Aurora Dialysis Center Upgrades

City of Aurora Building Division
Project: **Davita Tenant Improvement**
Address: **1411 S. Potomac St. # 100**
Occupancy Group: **B**
Construction Type: **II thr.-SPK.**
RSN: **1322345**
Permit: **18-1529237 LT**

City of Aurora Building Division
Reviewed for Code Compliance
Approved as Noted: **pmckown**
Date: **SEP 26, 2018**
2015 INTERNATIONAL CODES & 2017 NEC

DWV FLOOR PLAN
SCALE: 3/16" = 1'-0"
NORTH

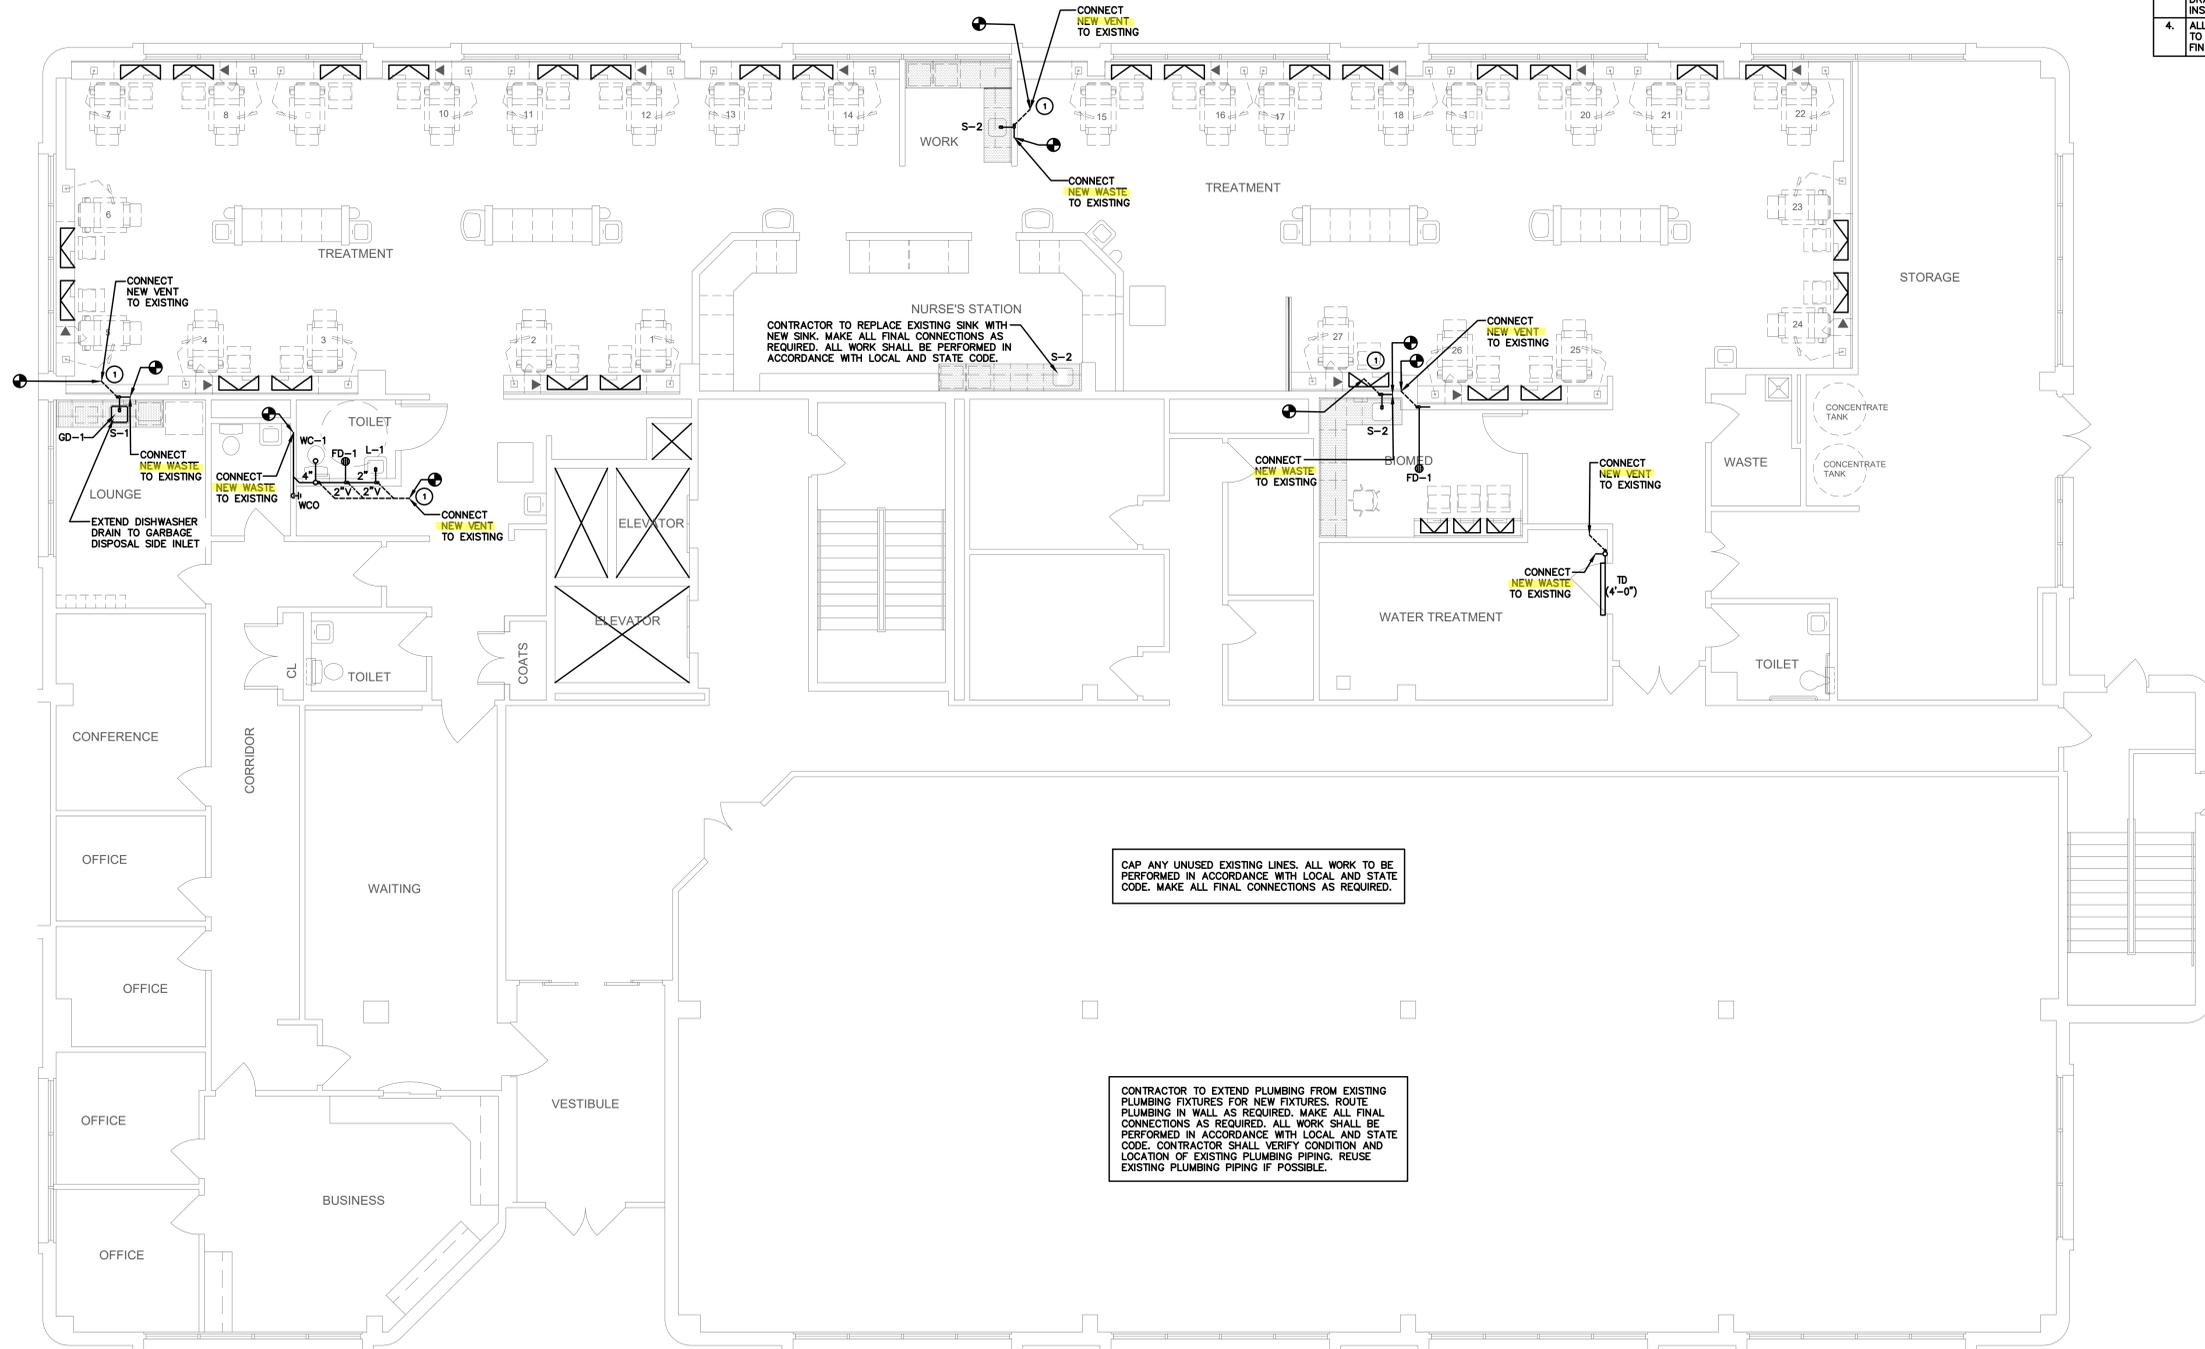
Provide drains no smaller than allowed by 2015 IPC 709.1 and 710.1(1)

3 WALL MOUNTED TMV
 SCALE: N.T.S.

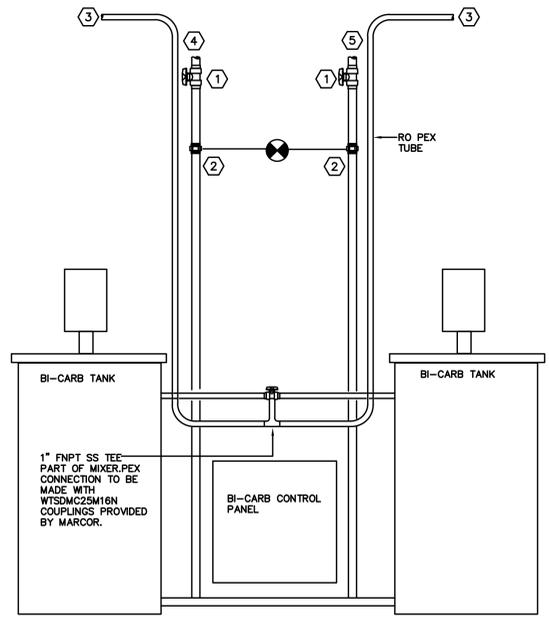
Provide for thermal expansion on hot-water supply system as required by 2015 IPC 607.3 or IRC 2903.4

4 CENTRAL BI-CARB R.O. & B.C. CONNECTION DIAGRAM
 SCALE: N.T.S.

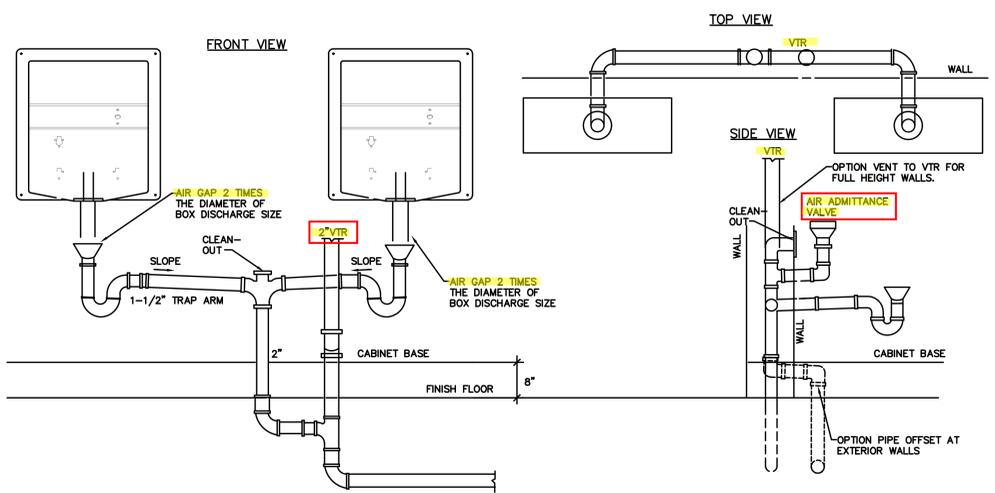
Provide drains no smaller than allowed by 2015 IPC 709.1 and 710.1(1)

POWER PLAN
SCALE: 3/16" = 1'-0"
NORTH

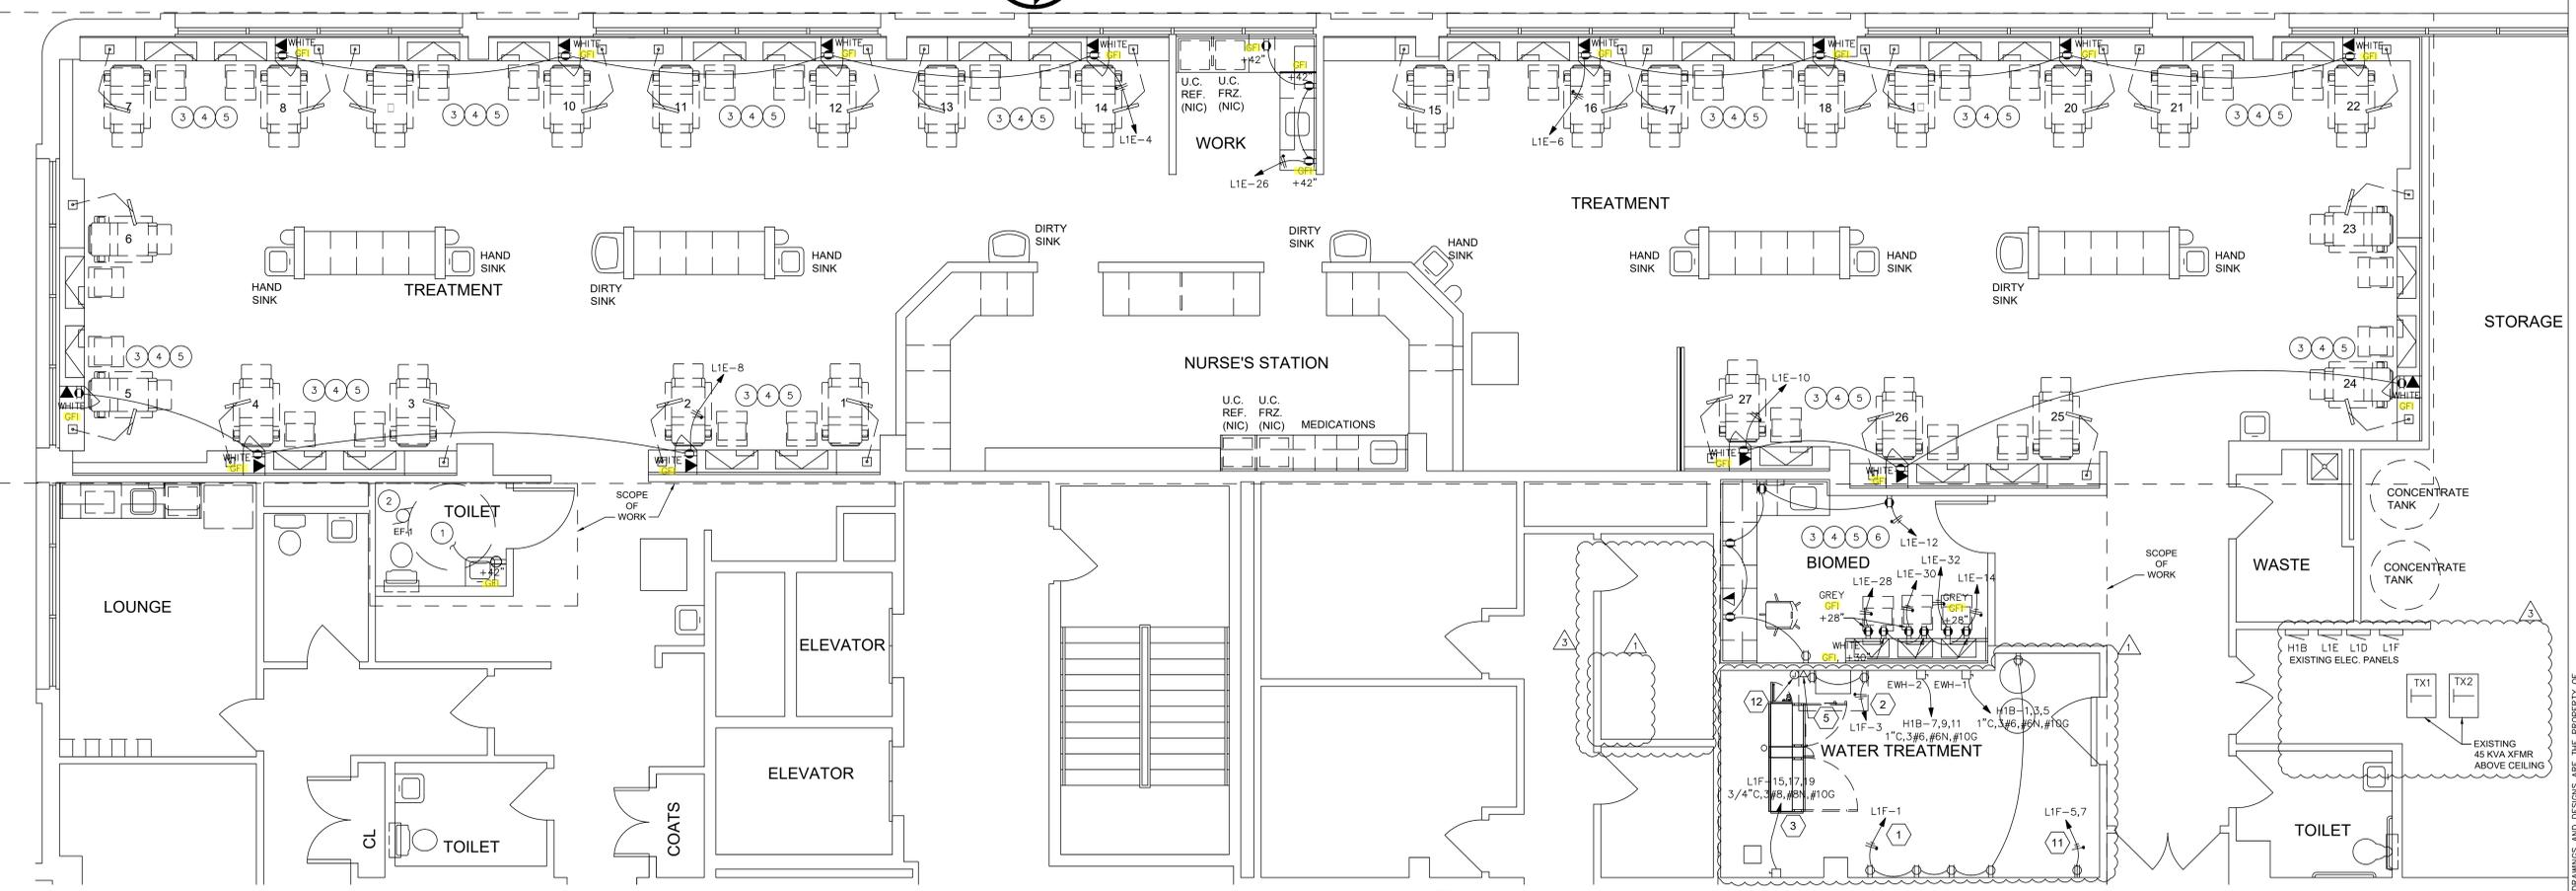
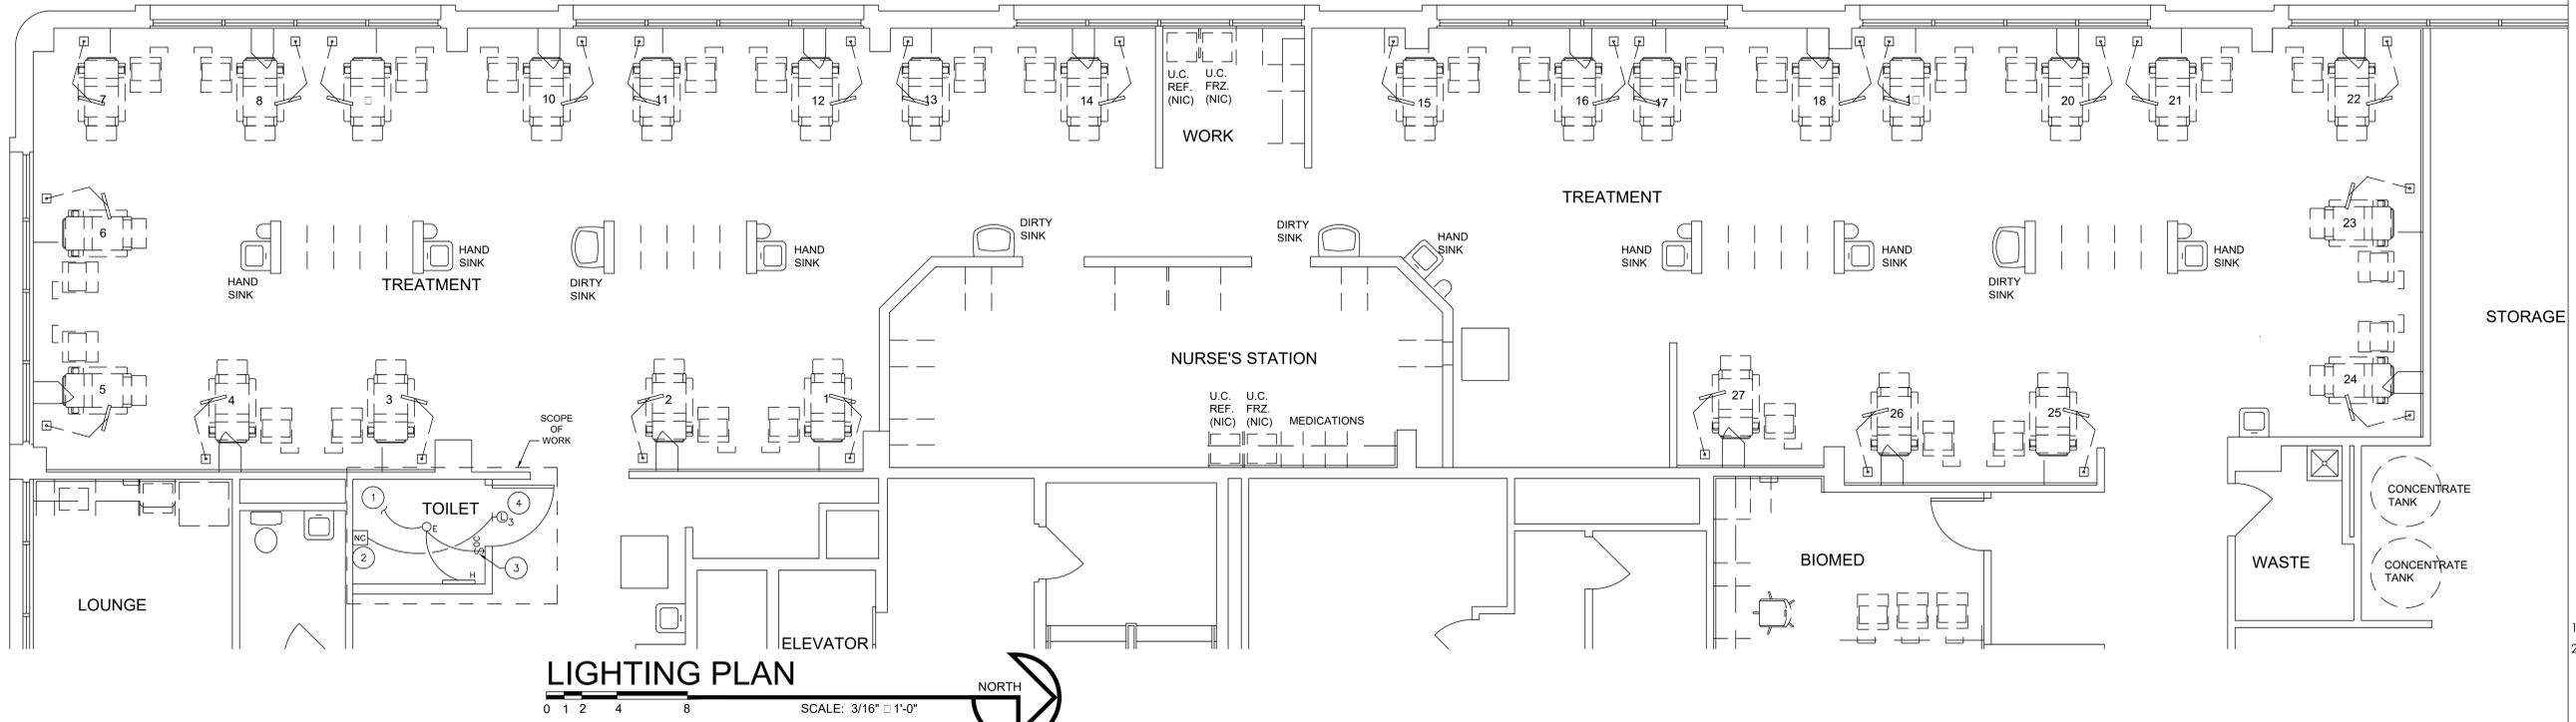
Install electrical connections per 2017 NEC 110.14, identify disconnects per 2017 NEC 110.22 and provide working space around electrical equipment per 2017 NEC 110.26.
